D3394-3 LUG

DRAWING NO. D3394	TITLE LUG	REV. B	<b>DART AEROSPACE LTD ENGINEERING ORDER</b>		D.E.O. NO. D3394-B-1	SHEET NO. SHEET 1 OF 1	SCALE NTS
DRAWN AJS	CHECKED	MFG. APPR.	APPROVED		DE APPR.		
DATE 09.11.04	DATE 09.11.04	DATE 09.11.04	DATE 09.11.04		DATE 09.11.04

DRAWING NO. D3394	TITLE LUG	REV. B	DART AEROSPACE USA, INC ENGINEERING ORDER		D.E.O. NO. D3394-B-2	SHEET NO. SHEET 1 OF 1	SCALE NTS
DRAWN <i>GP</i>	CHECKED <i>Sc</i>	MFG. APPR. <i>M</i>	APPROVED <i>MP</i>		DE APPR. <i>MP</i>		
DATE 11.05.02	DATE 11.05.09	DATE 11.05.09	DATE 11.05.09		DATE 11.05.09

SECTION A-A

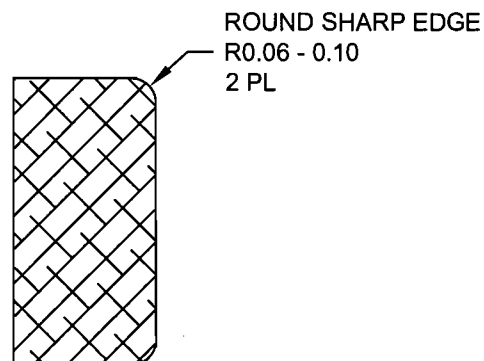
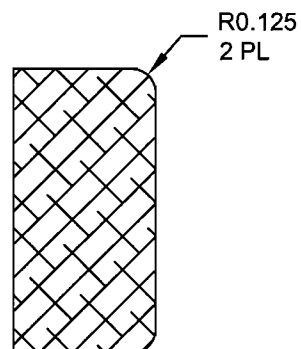
SHEET 4 ZONE A,1 MODIFY SECTION A-A AS SHOWN:

REASON: DRAFTING ERROR

D3394-1RG LUG (SHOWN)  
D3394-3RG/-5RG LUGS (SIMILAR)  
D3394-041RG/-043RG/-045RG LUG ASSEMBLIES (SIMILAR)

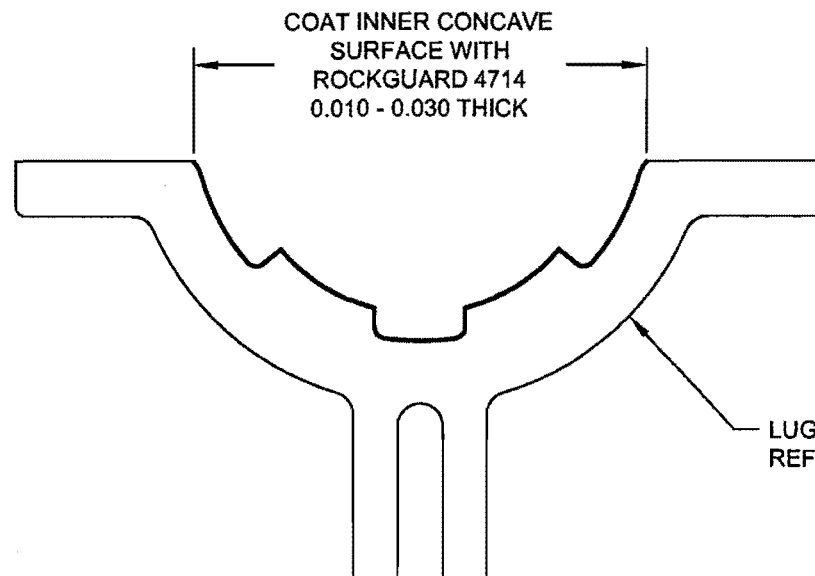
ADD D3394-xRG OPTION

D3394-xRG MOUNTING LUGS ARE IDENTICAL TO D3394-x MOUNTING LUGS, HOWEVER AFTER FINISH, COAT INNER CONCAVE SURFACE WITH "PLUS ONE ROCKGUARD 4714" AS SHOWN BELOW.
